OJAI UNIFIED SCHOOL DISTRICT

BID ADDENDUM NO. 3 ISSUED 4/18/2019

LIBRARY REMODEL AT NORDHOFF HIGH SCHOOL PROJECT NO. 2018-1714

ADDENDUM NO. 3

2 EAST ELEVATION
1/8" = 1'-0"

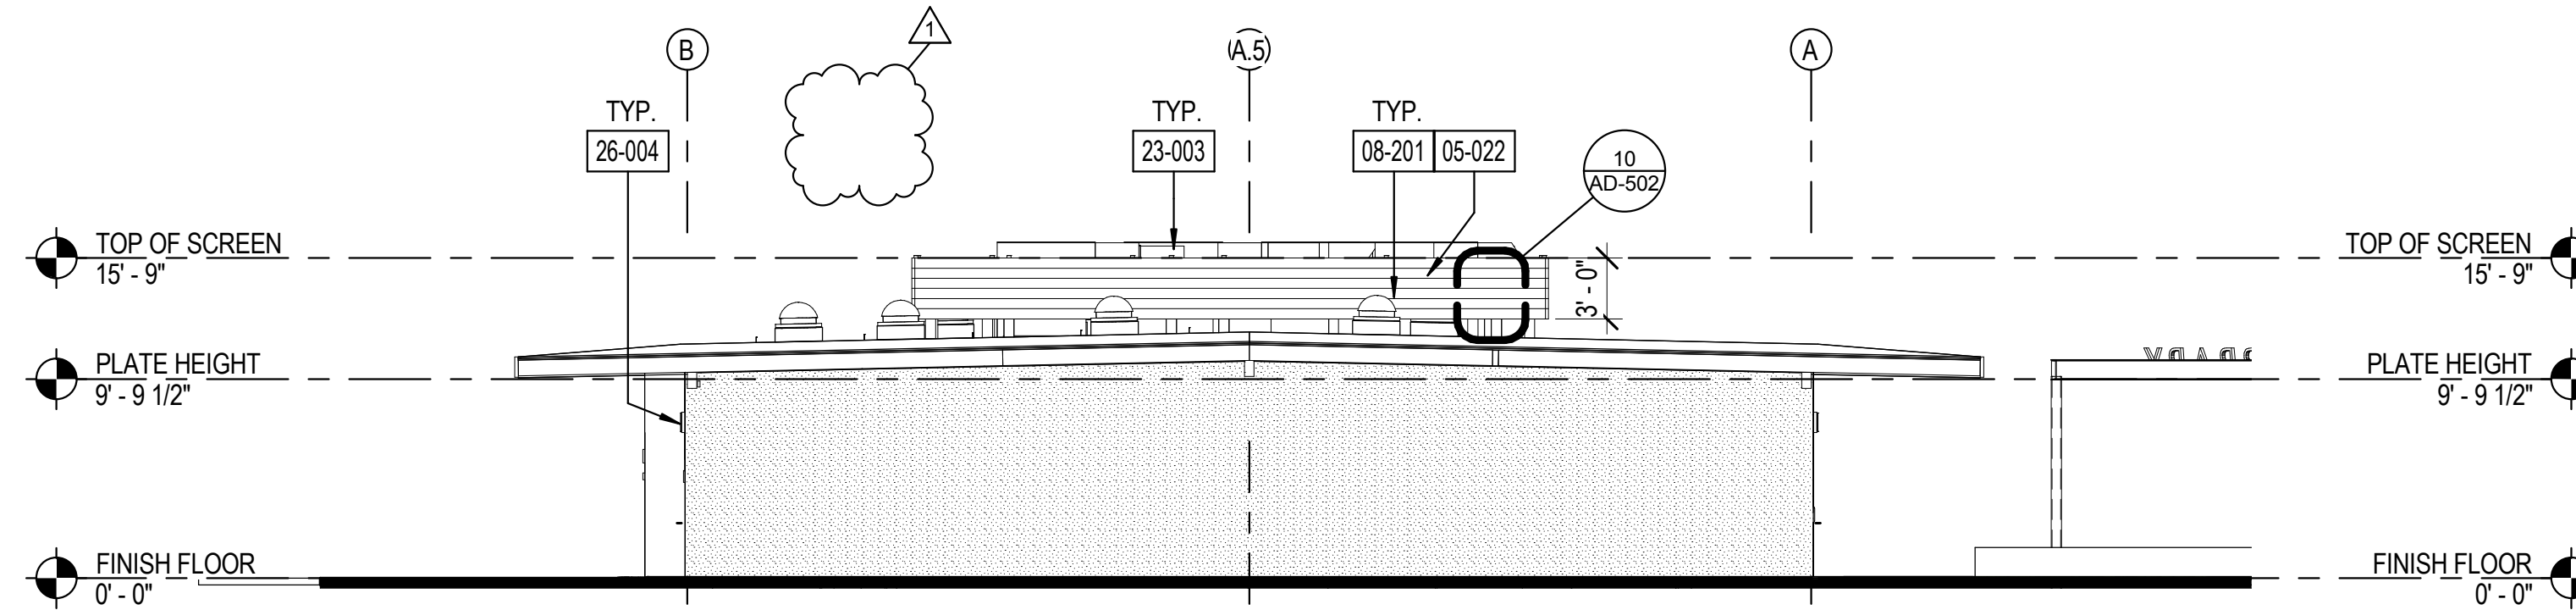
2) The Legend on exterior elevation plan, A-201, has only one graphic designation, which is for (E) Cement Plaster. This graphic designation appears to be indicated at the north, south and west elevations only and not at the east elevation.

3) Keynote 09-001 on A-201 notes Exterior Cement Plaster, indicating new plaster. This Keynote is indicated on the north & east elevations as typical, however as noted in #2 above only the east elevation is indicated to get new plaster, based on the graphic designation in the legend. Please clarify which exterior walls get a) new sheathing and b) new cement plaster.

- 2) East elevation now shows (E) stucco.
- 3) Keynote 09-001 removed from existing plaster. Applied to new plaster only.
